North Anna Unit No. 1  
Technical Specifications Changes  
Tavg = 587.8°F

North Anna Unit No. 2

Technical Specifications Changes

FIGURE 2.1-1 REACTOR CORE SAFETY LIMITS FOR THREE LOOP OPERATION, 100% FLOW

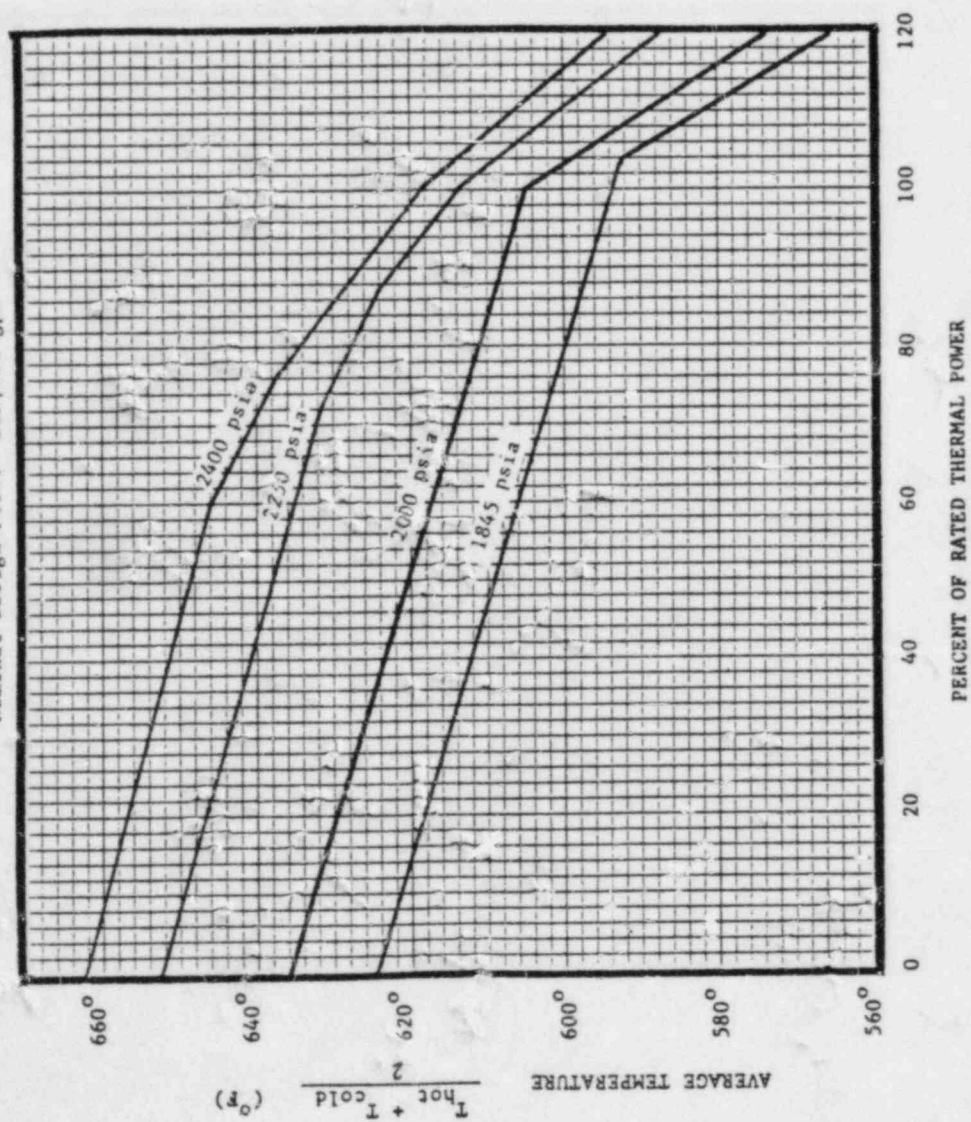
$T_{avg} = 587.8^{\circ}\text{F}$

Nominal Tav<sub>g</sub>: 587.8°F  
 Nominal Design Flow: 285,000 gpm
